DER Register

Delivery Team 1 – Data Model
March 2019

Update on project

Relationships between levels – is change needed?

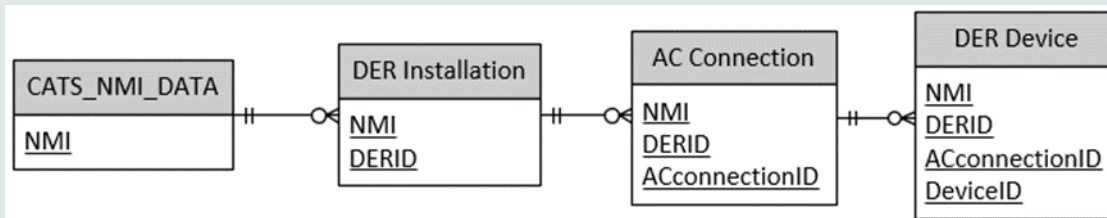
- A data model with NMI 1:1 ratio to DER installation would be the preferred data model. Having multiple aggregates of DER does not make sense under the examples provided.

- The purpose of level 2 in the data structure is unclear. There is concern that the level 2 trip (frequency and voltage) settings are both duplications of trip settings captured in level 3 devices and not complete enough to capture the complete response of sub devices.

- Level 2: DERID: it is unclear of the benefit of assigning a DERID to each installed asset. The critical piece of information is the export capacity at the NMI.

- Level 4: Separating DER device requirements from AC Connection data requirements (level 3) is going to cause confusion where devices are fully integrated (such as a BESS with an integrated inverter). The data model needs to avoid duplication of the same device level information being provided twice.

Q1: Should we change from a 4 level to a 3 level data structure?
